Docket No. 52-021  
MHI Ref: UAP-HF-11242

Markup DCD for Section 9.2

July 2011

#### 7.6.1.6 RCP Thermal Barrier HX CCW Return Line Isolation Interlock

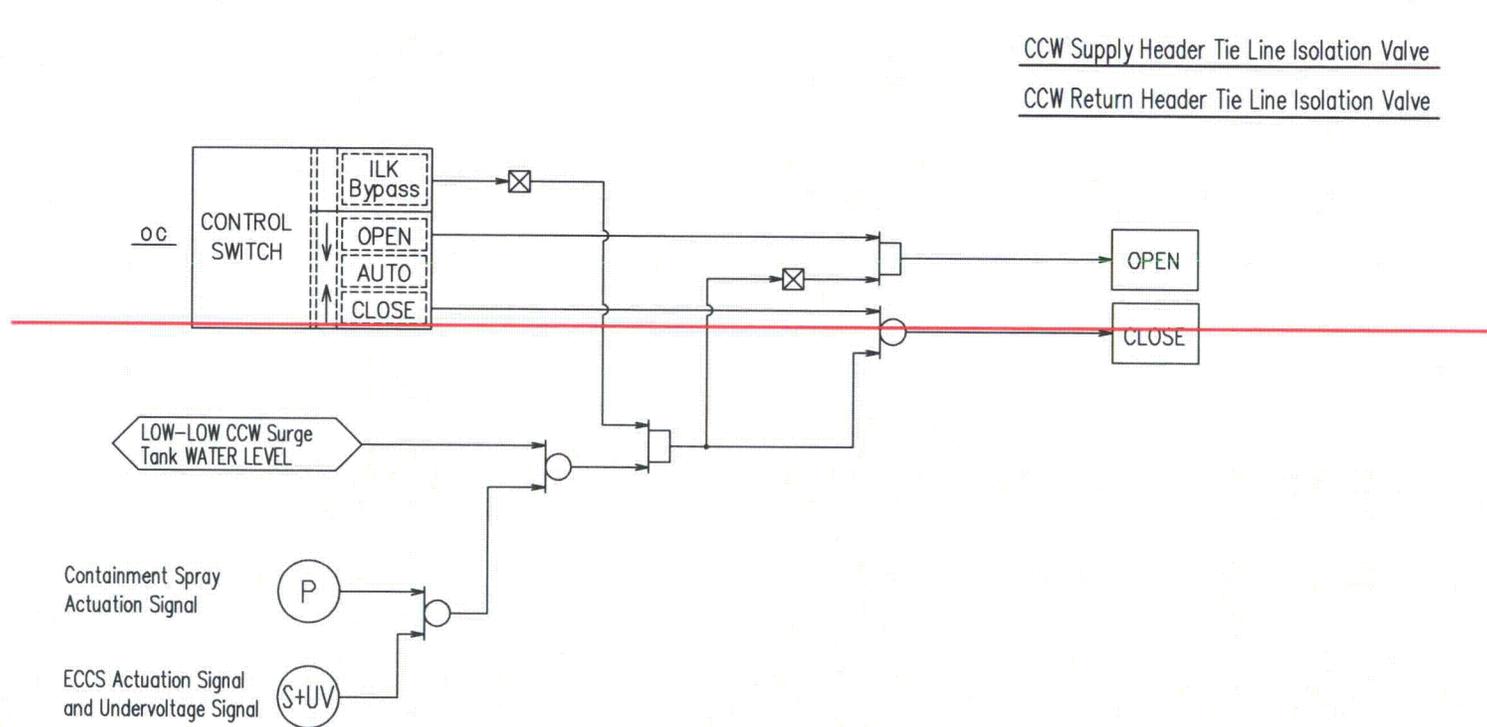
Each CCW subsystem supplies cooling water to the RCP thermal barrier heat exchanger. Two motor-operated valves and flow meters are located at the CCW outlet line of the RCP thermal barrier heat exchanger.

These valves close automatically upon a high flow rate signal at the outlet of this line in the event of in-leakage from the RCS through the thermal barrier heat exchanger, and prevent this in-leakage from further contaminating the CCWS.

The interlocks for these valves are shown in Figure 7.6-7. The safety related interlocks preclude multiple valve misalignment due to spurious commands from ~~operational~~ VDUs.
